SITE PROBLEM  
REPORT TRANSMITTAL

FILE: 13-14-386  
CONTRACT NO: 620-00 14  
SPR 386  
TITLE Electronic  
Relief valve modification  
DATE: 3/27/78  
STATUS CODE C

# SITE PROBLEM REPORT

CUSTOMER Toledo Edison Company	ORIGINATOR F.R. Faist	DATE 11/2/77	DOC. NO. CONT. NO. 13 - 600-0014	SPR NO. 386
VENDOR Crosby	P.A. NO. 023 090 IS		PART NO./IATA NO. 28/041/005	GROUP NO. 11/1/1
TITLE (MAX 30 CHARACTERS) Electronic Relief Valve Modification			PROBLEM CONTACT J. E. Anderson

CROSBY, W. E. & G. C.  
WREN, J. A. MACE  
W. C. (PILOT W. E.)  
WV-SN

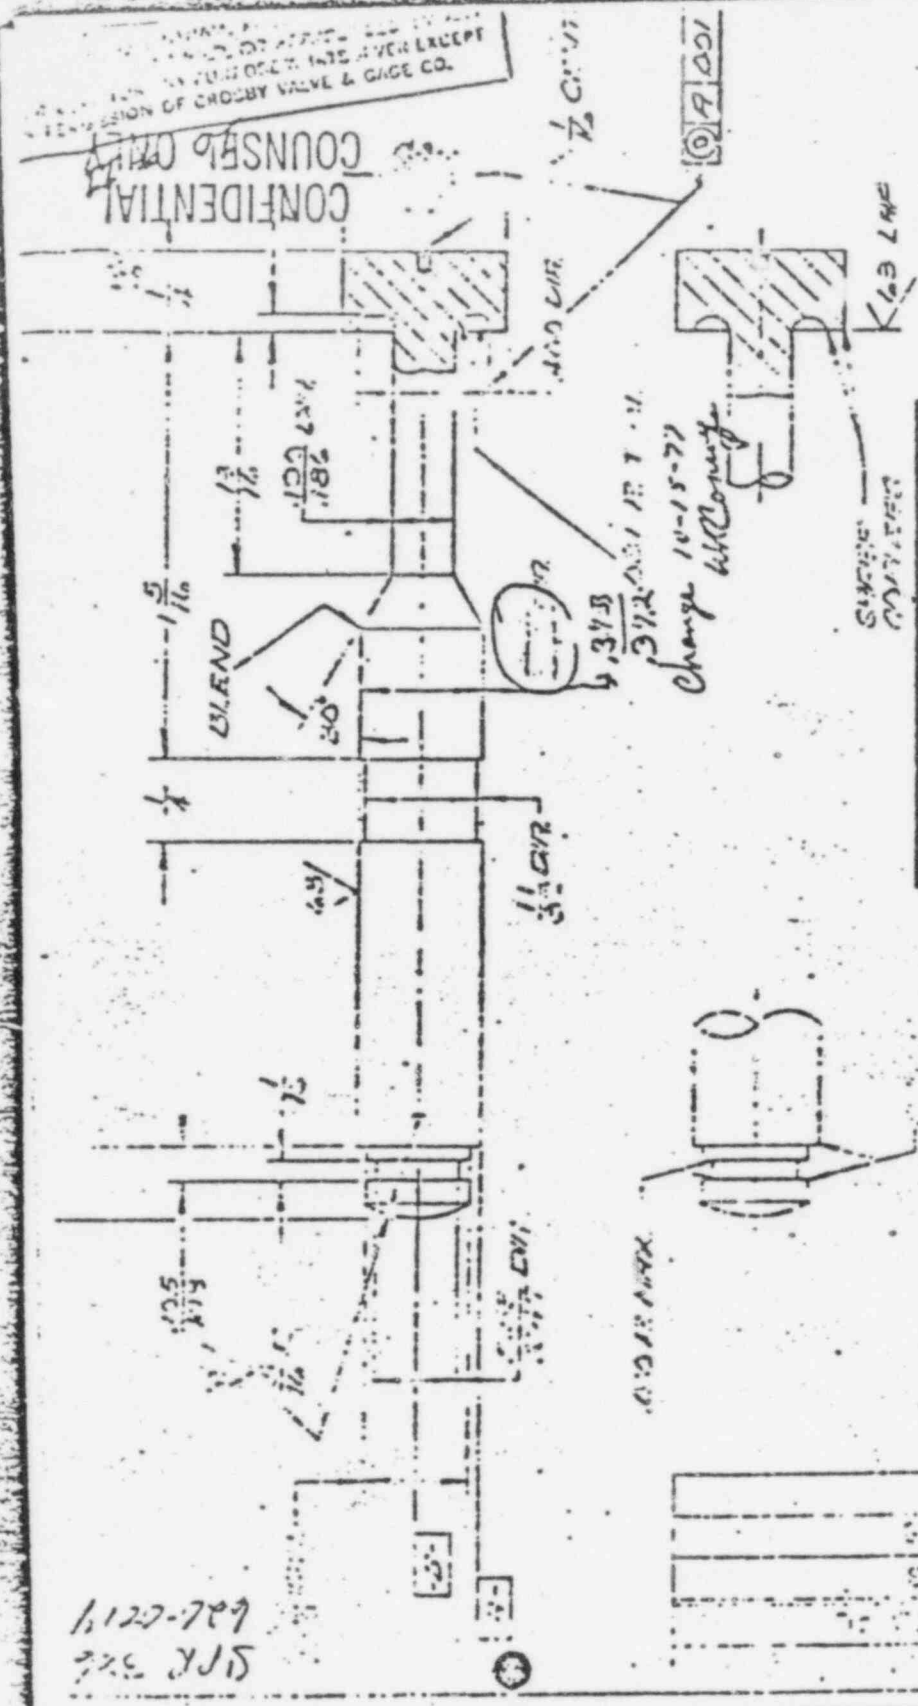
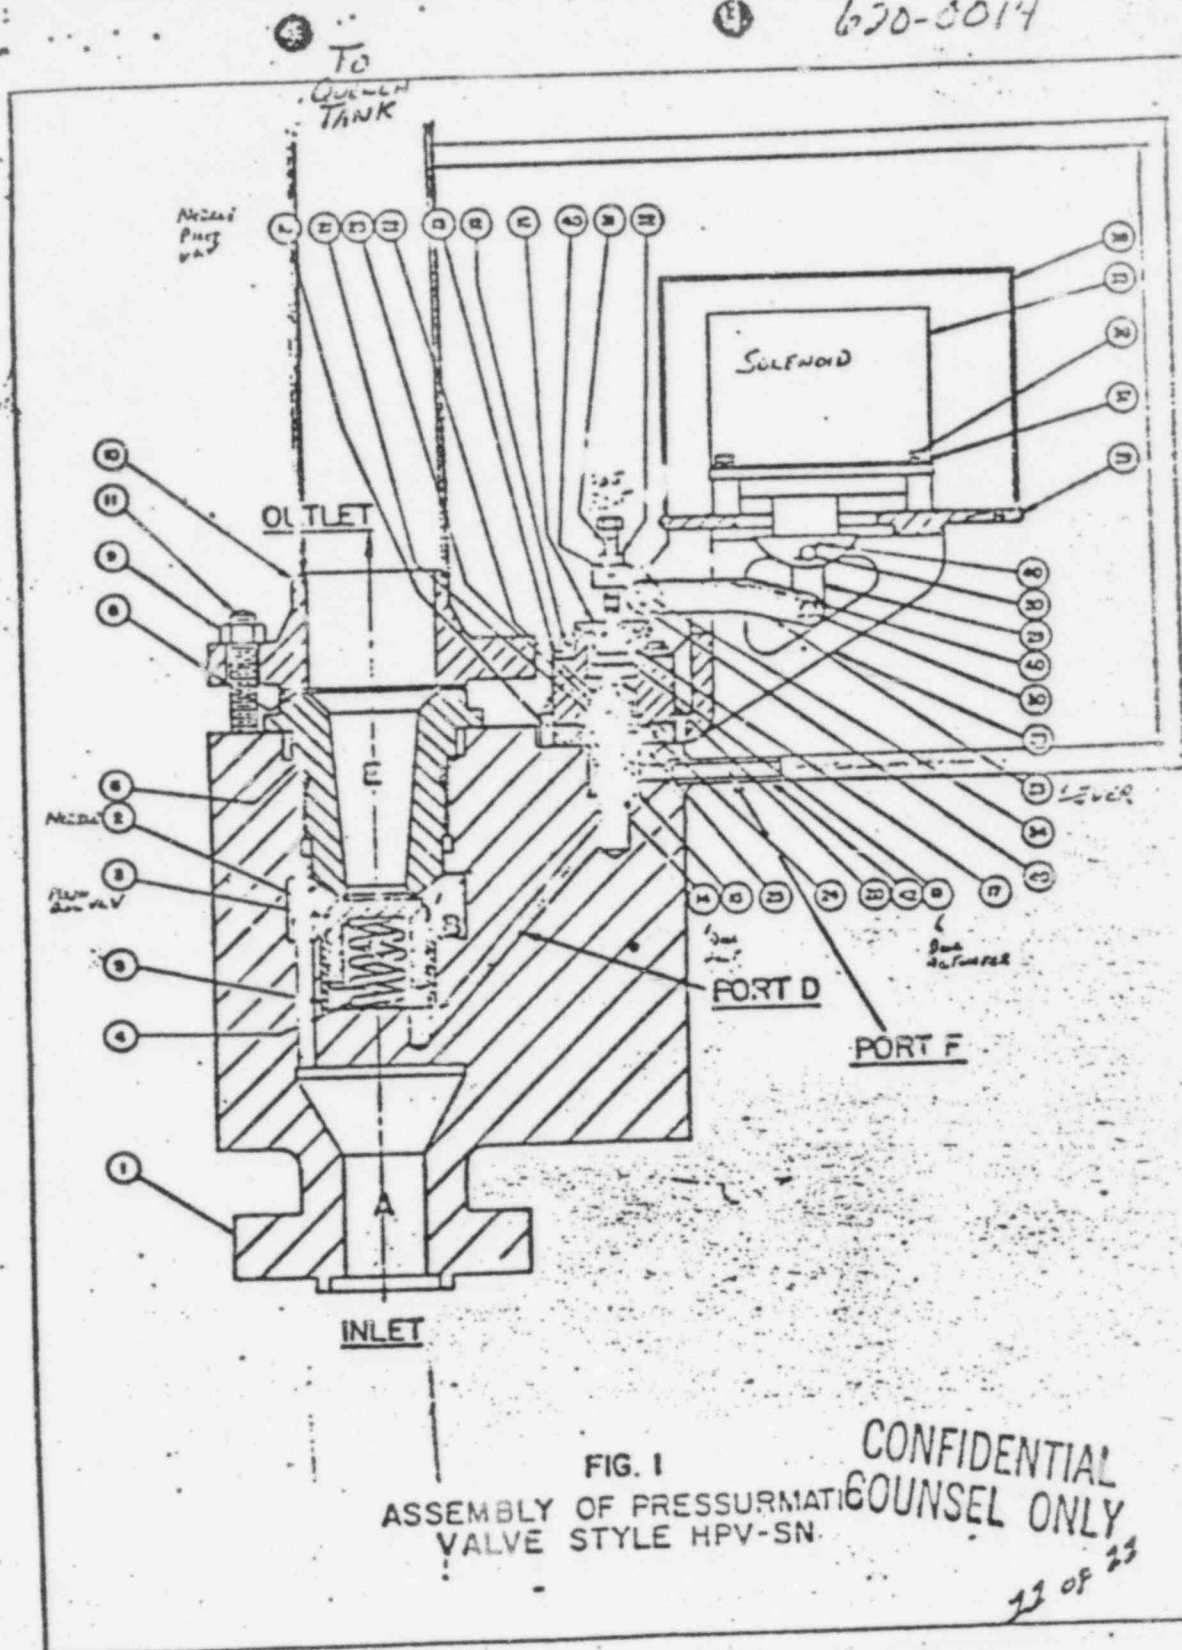
The Crosby representative furnished a detailed drawing of the pilot valve stem requiring a diameter of .374. This was changed to read .373 diameter .372.

by the Crosby rep., and the stem was modified accordingly by TECO Maintenance under the direction of the Crosby rep. This modification resulted in opening the clearance between the stem and the nozzle thus eliminating the binding. The nozzle was also reamed out with a reamer the same size, no material was removed.

All parts were cleaned and assembled. The solenoid linkage was adjusted to drop the adjustment bolt more squarely on the disc actuator. In addition, the adjustment bolt was positioned to move the pilot valve stem off the seat a maximum of .125". It had been moving off the seat some .375".
